PME Planning Services

Parking Area Details

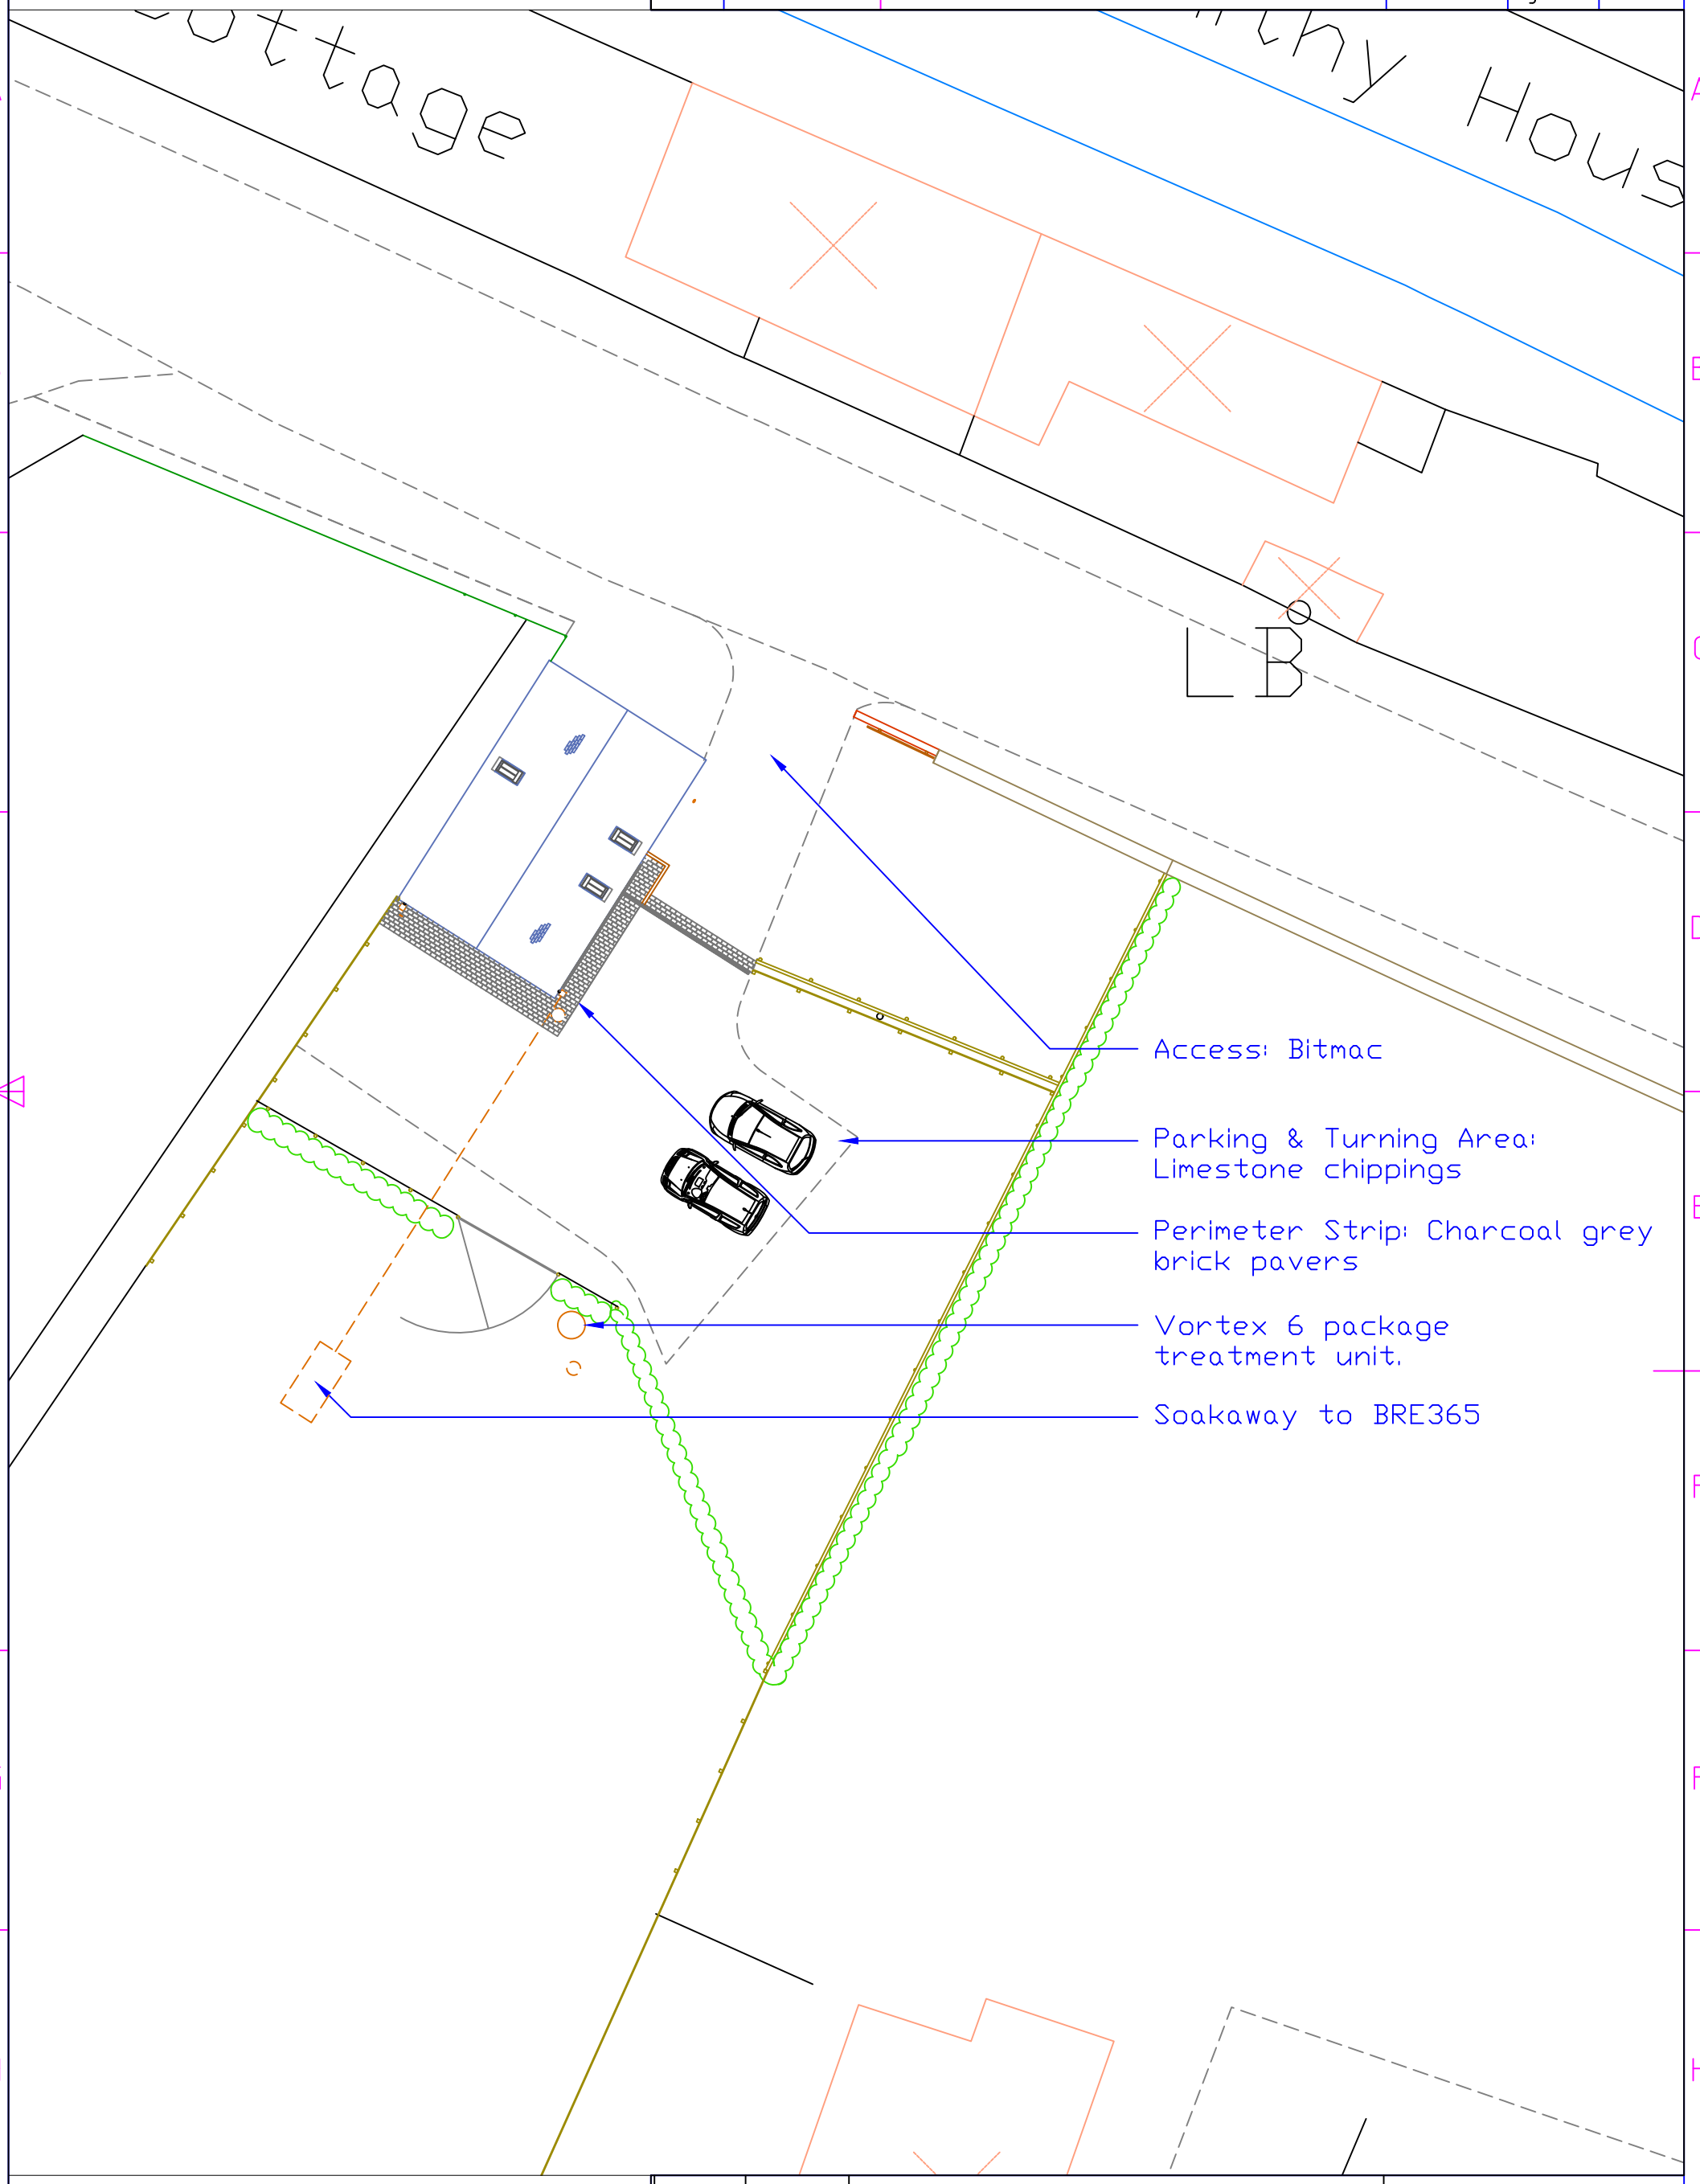
1). Parking area repositioned to aid manoeuvring
2). Parking area surfacing changed to limestone chippings to improve appearance
3). Driveway surfacing made non permeable for durability.
4). Surface water interceptor drains and soak-away to BRE365 provided.
